Grand Canyon Village Mass Grading

CITY OF LAS VEGAS		DATE:
INTER-OFFICE MEMORANDUM		January 20, 2021
TO: Land Development Services Department of Building & Safety		FROM: Jennifer Shinn, P.E. Flood Control, Engr. Associate Department of Public Works
SUBJECT:	Drainage Study for:	COPIES TO:
Grand Canyon Village Mass Grading		VTN
Cross Streets:	Grand Canyon Dr. & Skye Canyon Park Dr.	Grand Canyon Village, LLC
File Number:	F:\Depot\DSMemos\DS5398A.doc	Bart Anderson, P.E., DevCo
Parcel Number:	125-07-601-009, 125-07-601-010	NDOT
Zoning Action:		
FEMA Flood Zone	YES NO X	
Proposed Storm Drain	YES NO X

Technical Drainage Study for

GRAND CANYON VILLAGE
FIGURE 6- EXISTING CONDITION BASIN MAP

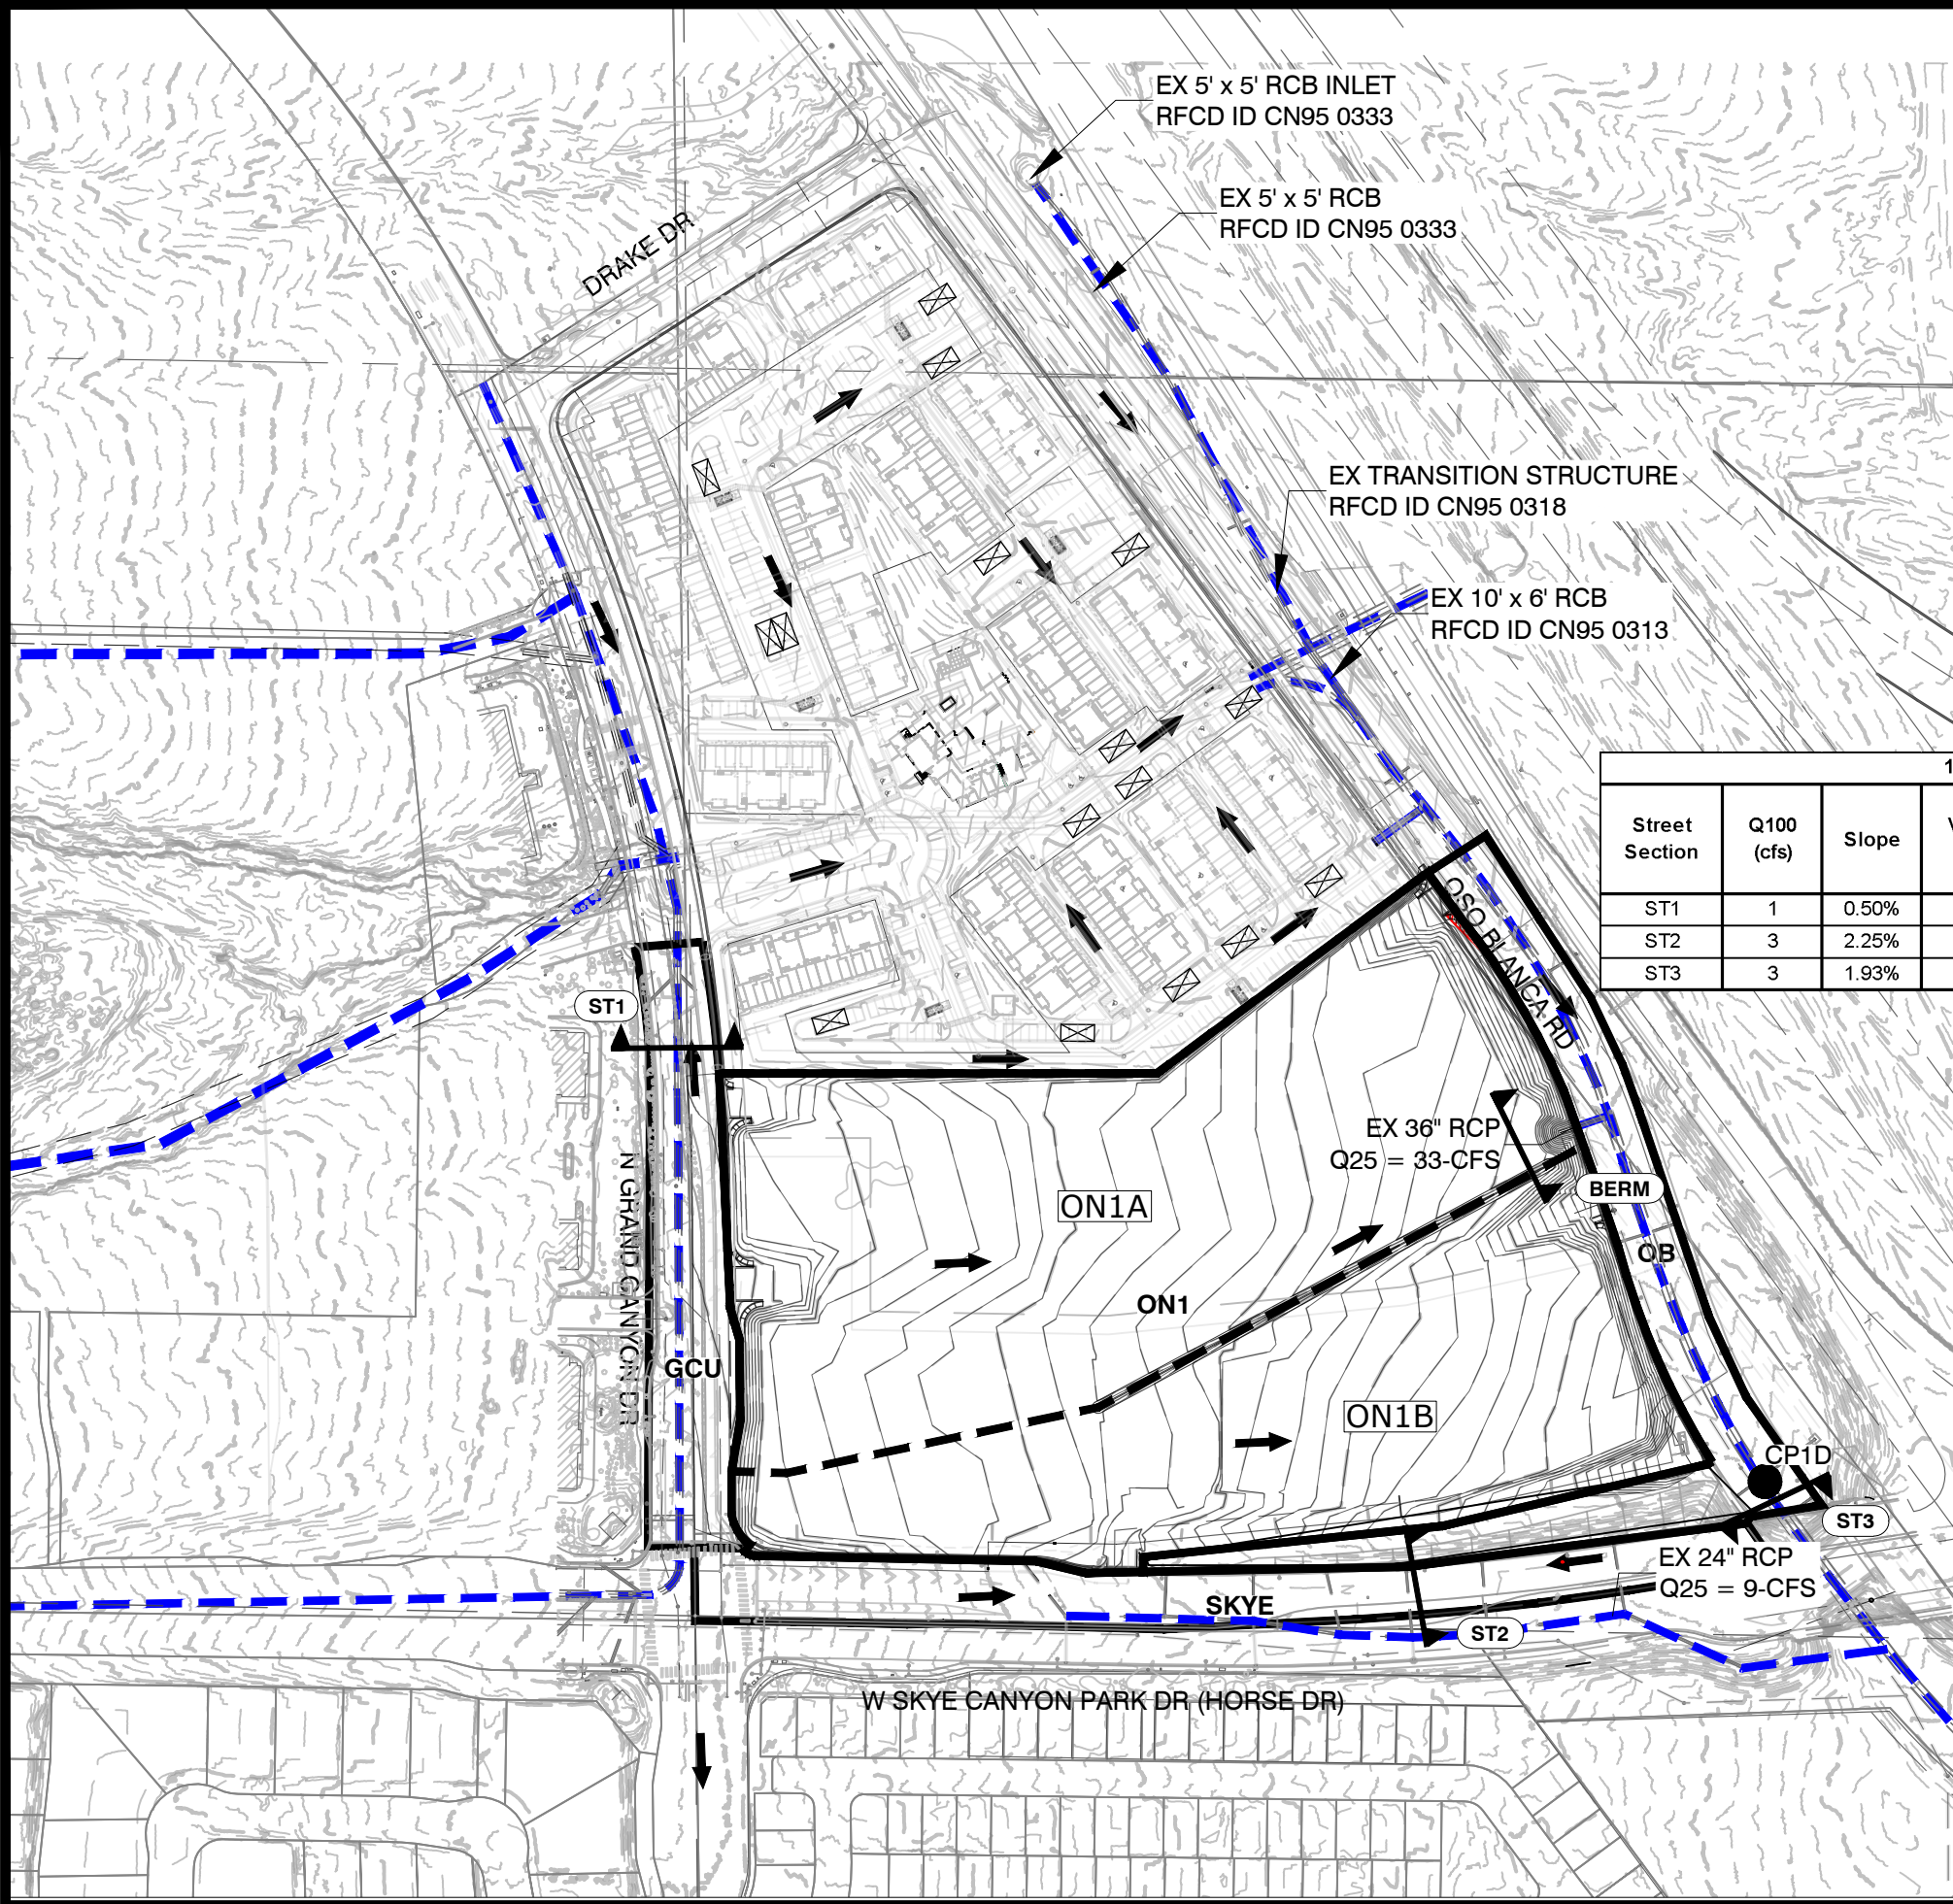
3. Provide printed copies of the Drainage Basin maps, Figures 6 and 7 were not provided with physical copy.
4. Provide erosion control mitigation for the steep slope that sheet flows onto Oso Blanca Dr from basin ON1b.

5. ON1a is considered to all flow to the existing 36" RCP. The northern corner of basin ON1a clearly bypasses this inlet and flows onto Oso Blanco Dr. This flow needs to be considered in the street hydraulic analysis.

7. Hydraulic section ST3 for existing condition should be evaluated for combination point CP1E flows rather than basin OB flows.
8. Hydraulic Section ST3 for developed condition should be evaluated for combination point CP1D flows rather than basin OB flows.
9. Hydraulic section ST1 for developed condition on figure 7 shows it is considering $\frac{1}{2}$ of the basin GCU (1 cfs) however the report and flowmaster show that it considers all of basin GCU (4 cfs). Resolve this discrepancy.
10. Label the existing storm drain facilities with their respective CLV Drawing Numbers.

GRAND CANYON APARTMENTS
FIGURE 7 - DEVELOPED (MASS GRADING)
CONDITION BASIN MAP

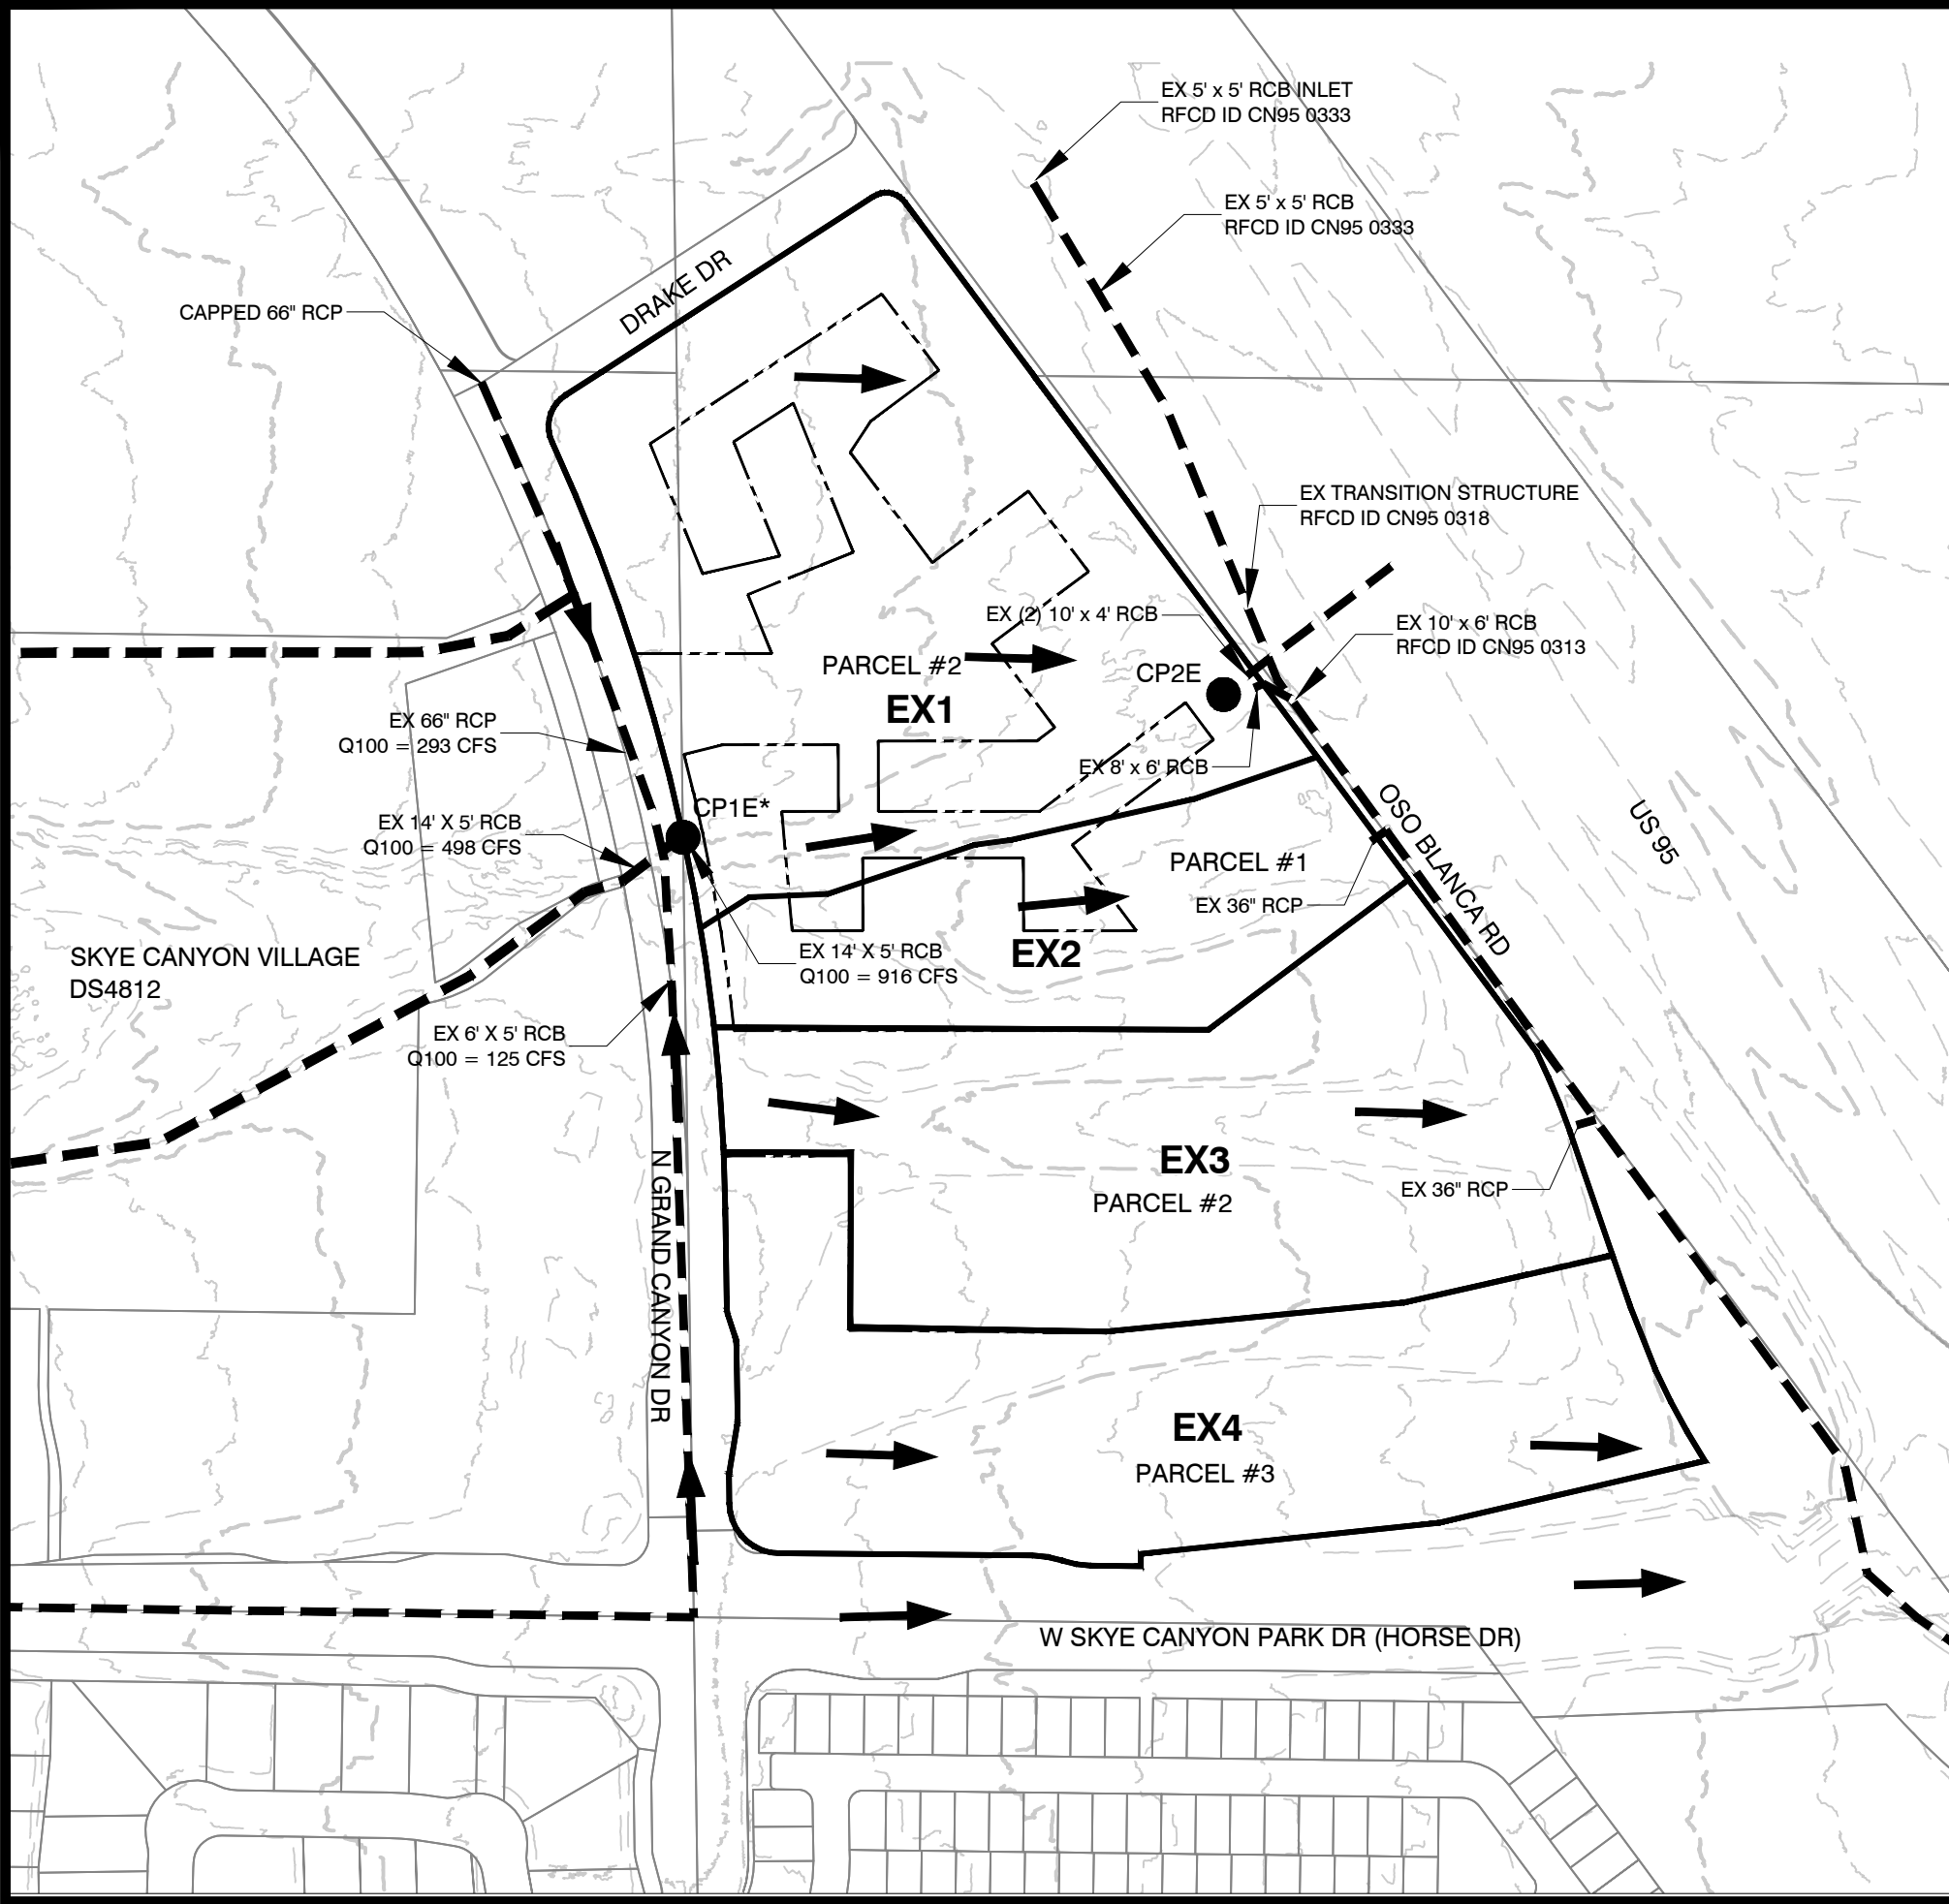
6. Per Standard Form 4 the lag time for ON1 is 0.136 however the developed condition HEC-1 model uses 0.135. Update accordingly.
